Columbia County Building Permit

000024957

This letter is an Addendum to the Plans we certified for the referenced home. The contractor must follow the additional requirements in this Addendum in building the home. The additional information and requirements below follow the order of the plans review comments we received from you.

GAGLIANO ENGINEERED TRUSS PLAN
NOT TO SCALE

TYPICAL FRAME DETAILS
NOT TO SCALE

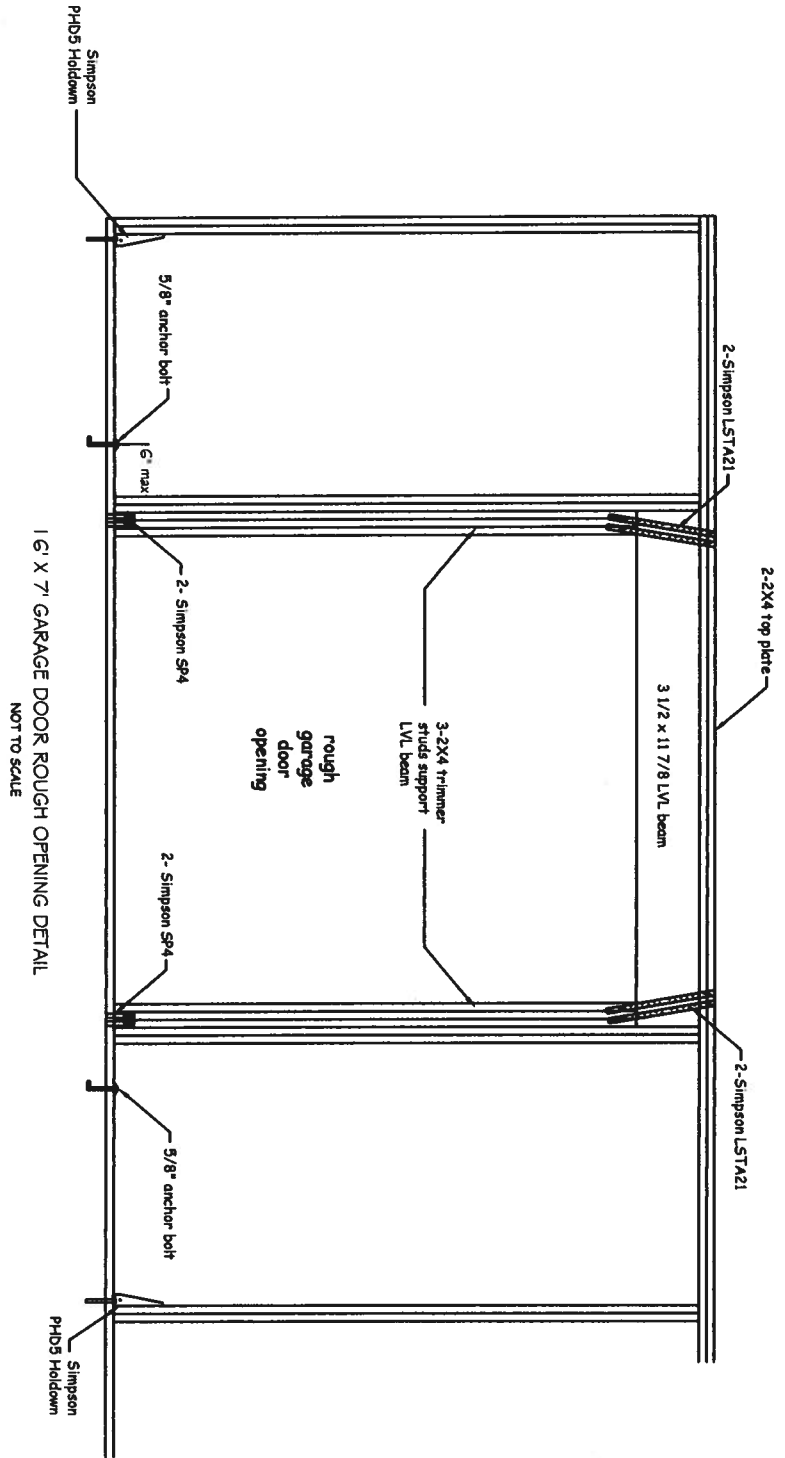
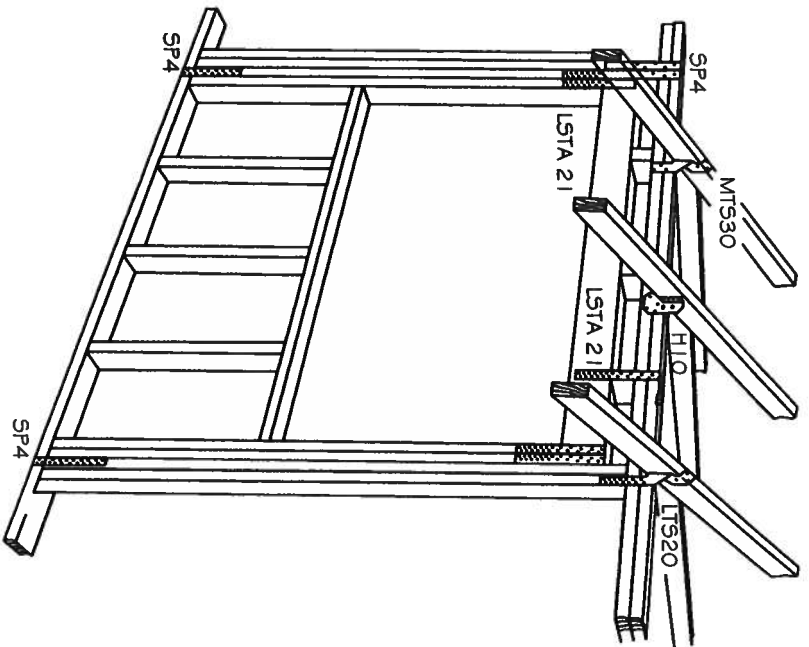
1. Sealed details are attached showing construction requirements for the window/door openings and for the opening to the garage.
2. Per requirements of the NEC, Arc-Fault interrupter devices shall protect all branch circuits supplying outlets installed within a bedroom.
3. Attached is a drawing of the roof truss framing plan that specifies the uplift protection requirement for each truss/girder attachment

TYPICAL FRAME DETAILS
NOT TO SCALE

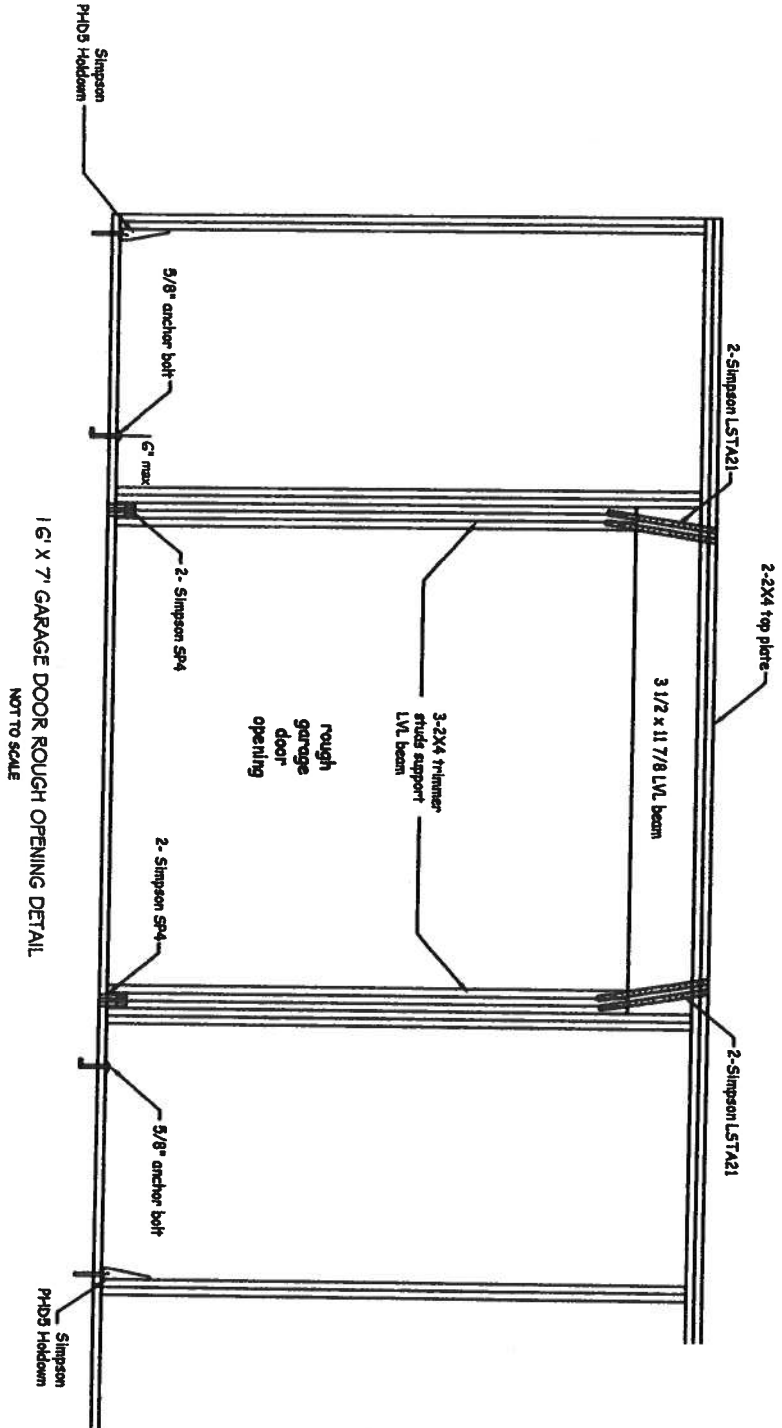
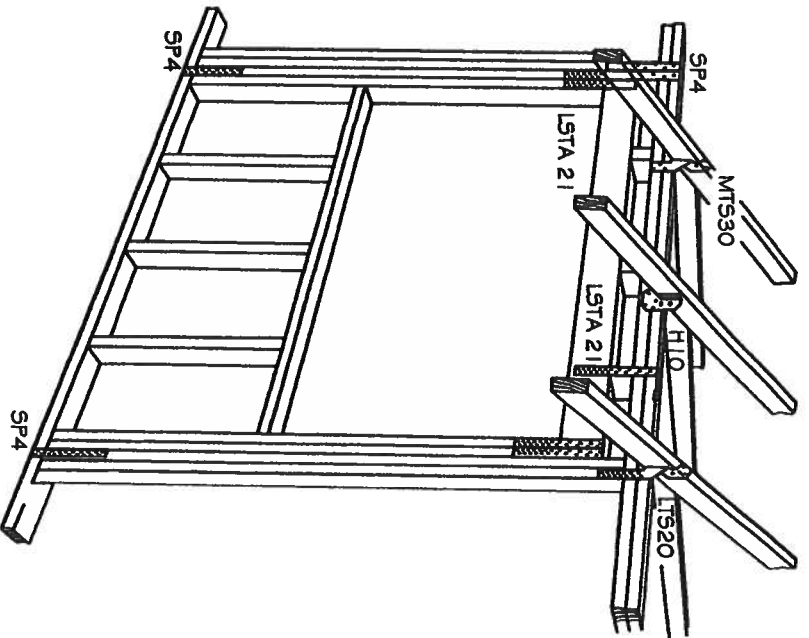
1. Sealed details are attached showing construction requirements for the window/door openings and for the opening to the garage.
2. Per requirements of the NEC, Arc-Fault interrupter devices shall protect all branch circuits supplying outlets installed within a bedroom.
3. Attached is a drawing of the roof truss framing plan that specifies the uplift protection requirement for each truss/girder attachment
